**Re: Envirosafe Services of Ohio, Inc.
 Oregon, Lucas County, Ohio
 EPA Identification Number: OHD 045 243 706; Ohio Permit Number: 03-48-0092
 Revised CMS Report**

**Responses to Ohio EPA March 21, 2011 Second NOD Follow-up
Corrective Measures Study Report
Envirosafe Services of Ohio, Inc. Otter Creek Road Facility**

January 7, 2011
Revised August 1, 2011
Revised April 30, 2012

**Table 6b: Proposed Groundwater Monitoring Program
 ESOI Otter Creek Facility, Oregon, Ohio
 Deep Till Contact Zone Monitoring**

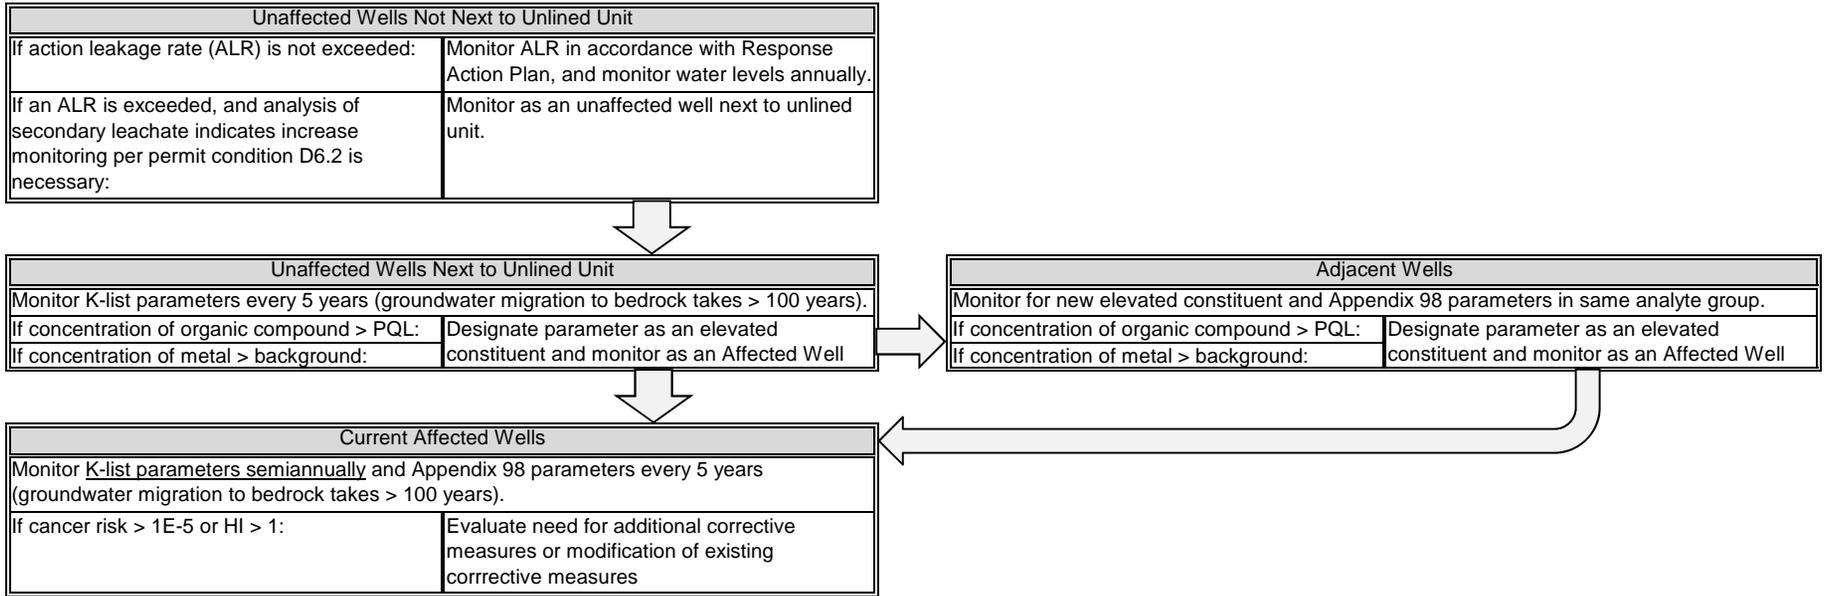
3. Indicate that ESOI's groundwater monitoring program will use action leak rates to trigger monitoring of Deep Till Zone wells that are adjacent to only double-lined landfills. See revisions in Section 9.2.2.3 and Table 6b.

6. Revised Table 6a as necessary. Table 6a has been revised.
7. Revised Tables 6b and c as necessary. Tables 6b and c have been revised.

**Table 6c: Proposed Groundwater Monitoring Program
 ESOI Otter Creek Facility, Oregon, Ohio
 Shallow Till Contact Zone Monitoring**

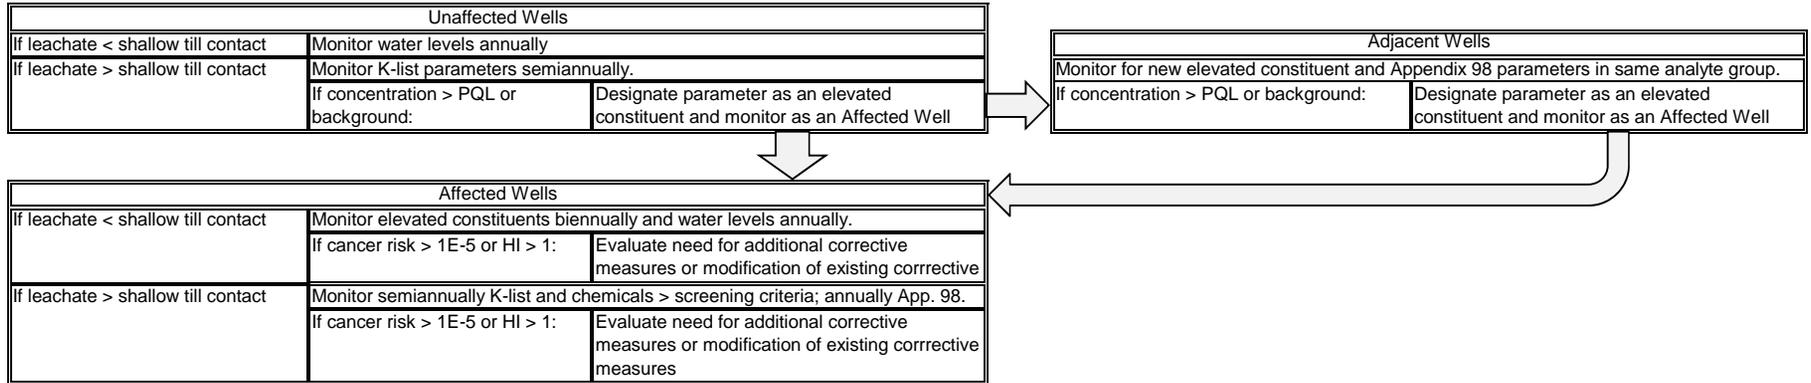
2. Indicate that background levels will be used in the groundwater monitoring program to identify "elevated" inorganics. See revisions in Section 9.2.2.3 and Tables 6a, 6b and 6c.
